**MANASQUAN PLANNING BOARD MEETING AGENDA
CONDUCTED WITH ZOOM
AUGUST 17, 2021 4:00 PM – TUESDAY**

Re: Boro File No. MSPB-R1630
Variance – Salt Air Properties
Block 165, Lot 15.01
43 Beachfront/42 First Avenue
R-4 Single-Family Residential Zone
Borough of Manasquan, Monmouth County, NJ

As per your request, I have reviewed the above-referenced application in accordance with the provisions of the Borough Land Development Ordinance. The documents reviewed in conjunction with this application include:

PROPOSED SITE PLAN
SCALE: 1" = 10'-0"
ALL OF THE INFORMATION ON THIS SITE PLAN IS BASED ON THE SURVEY DATED 1-8-21 PREPARED BY PAUL K. LYNCH, LAND SURVEYOR - PLUT ASSOCIATES, LLC - NJ LIC. NO. 35855 - P.O. BOX 1453 - WALL, NJ 07115 - (732) 681-4035.

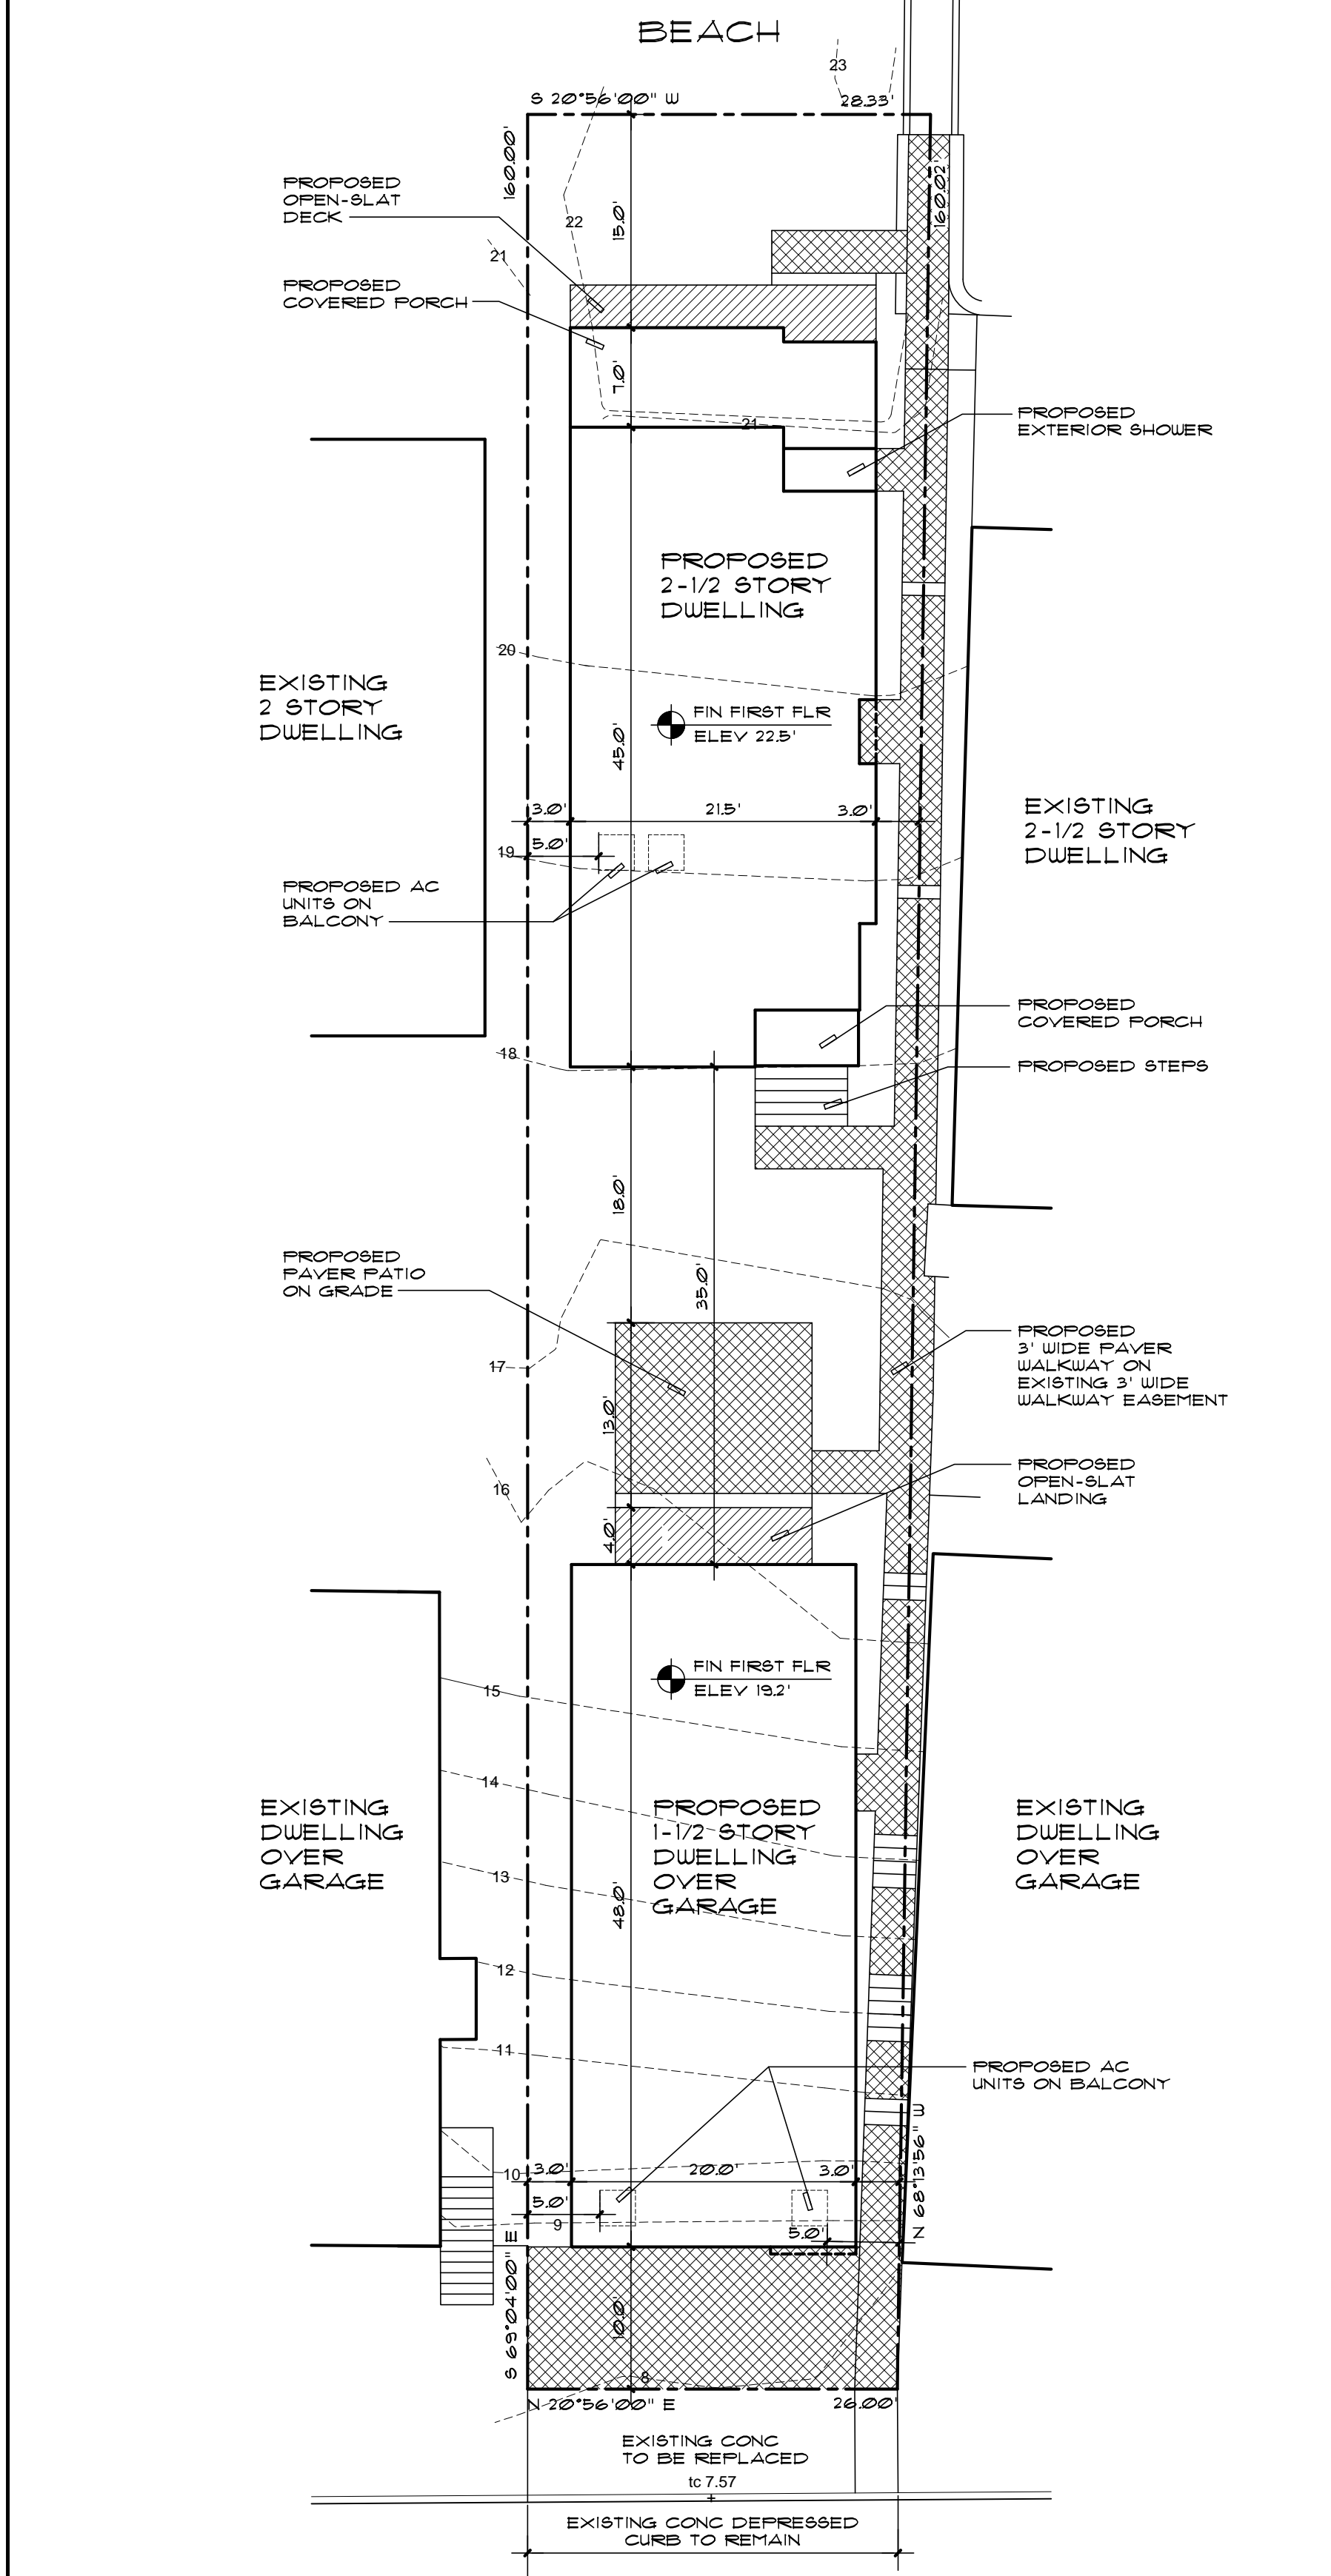
7. Three conforming parking spaces are provided within the First Avenue garage and two additional spaces are shown in front of the garage. These two spaces will be partially located within the right-of-way, but outside the roadway.

8. A dedicated walkway to the beachfront is proposed, partially located within the existing easement area with adjacent Lots 15.03 and 15.04.
9. A drainage recharge system in accordance with the Borough's stormwater ordinance is not required as the property is located within the R-4 beachfront zone
10. Construction details for the proposed pavers and any other site improvements should be provided on the plans.
11. The method of stabilizing the lot must be indicated on the plan.
12. A landscaping plan for the property must be provided. No trees will be removed as part of this application.
13. Any new utilities should be located underground if possible.
14. The two new dwellings will need to be serviced by separate water and sewer lines, the locations of which must be shown on the plans.
15. Any curb and sidewalk must be replaced along First Avenue as necessary.

des.	date	scale	As Noted
dwn. BAD	09-28-20	job no. 2201-188	
chk.	sheet 1 of 1	dwg. no. 63368	B

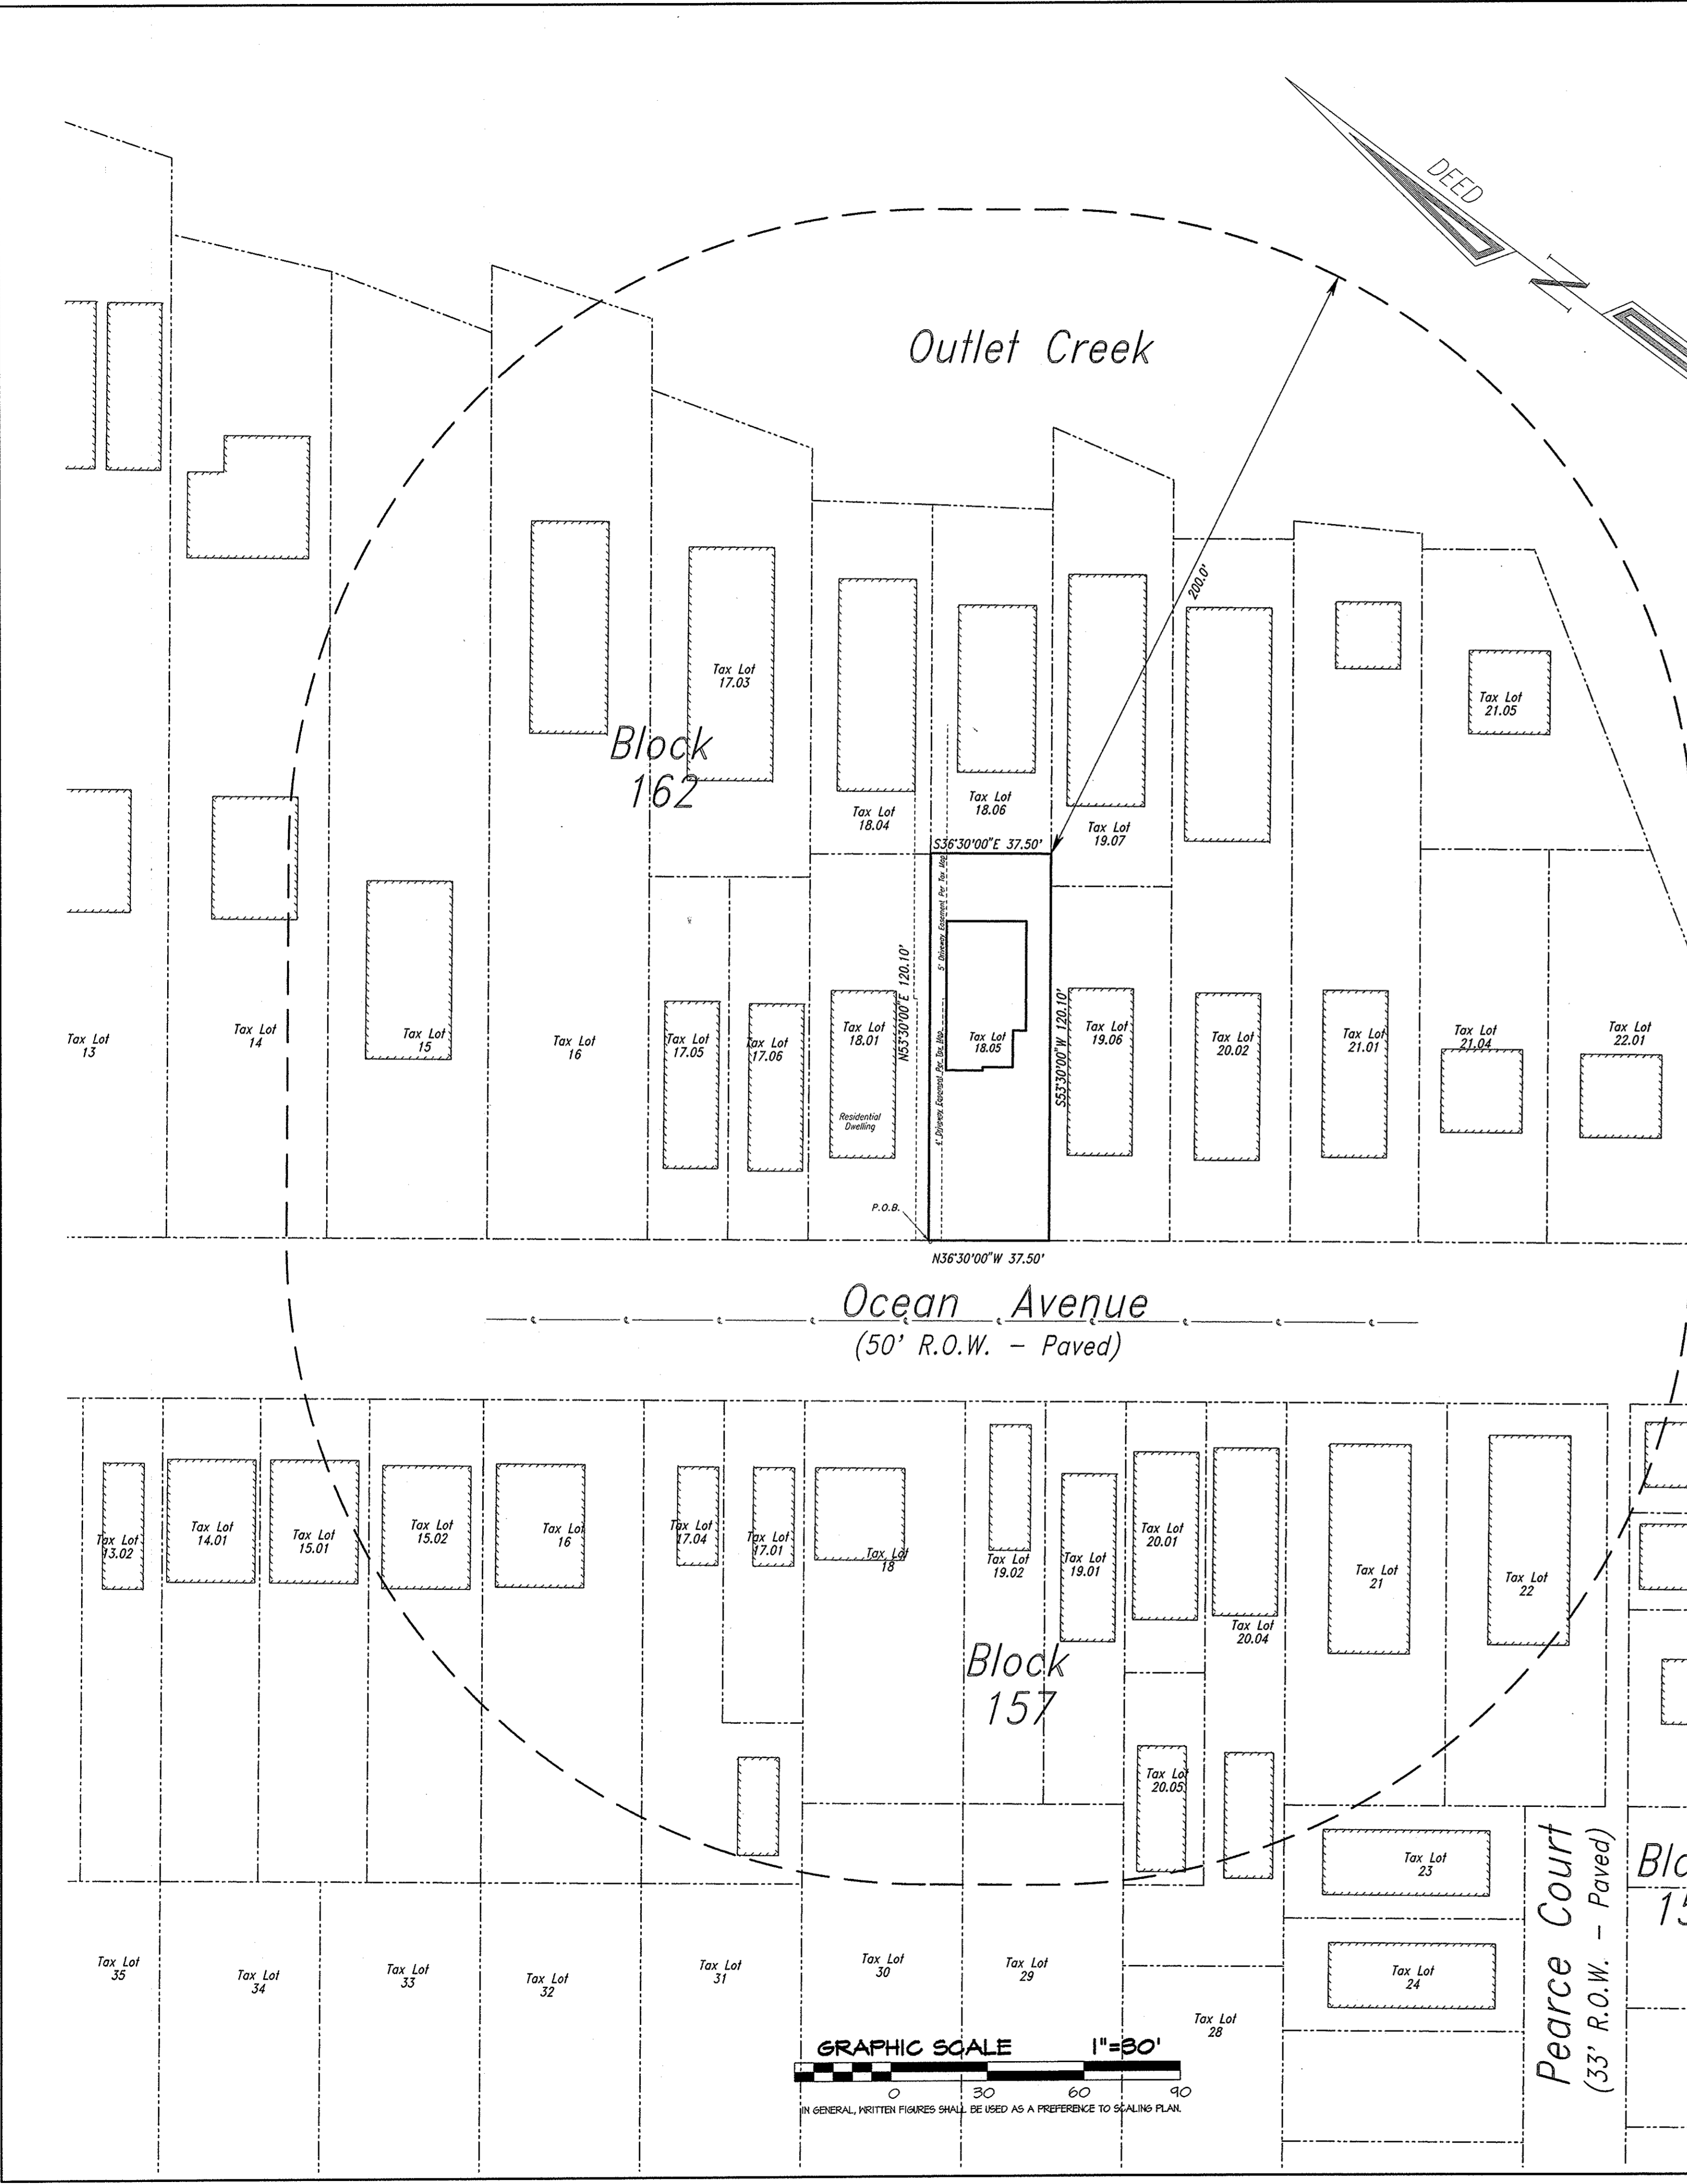
4. If a concrete landing is proposed for the front stairs it must be shown on the plan. This may also increase the lot coverage variance so the applicant's engineer should provide a revised coverage calculation if a pad is to be provided.

7. A grading plan for the property has been provided, however there appears to be a small low area at the rear northeast corner of the property. The applicant's engineer should comment on how this area will drain or be addressed.

11. The method of property stabilization (stone, grass) should be indicated on the plot plan.
12. Any proposed utilities should be located underground if possible. The locations of the water and sewer laterals should be shown on the plan.

4. Revised architectural plans must be submitted to demonstrate conformance with the submitted engineering plan.
5. Addressed. The concrete landing has been shown on the plan and included in the lot coverage calculation.
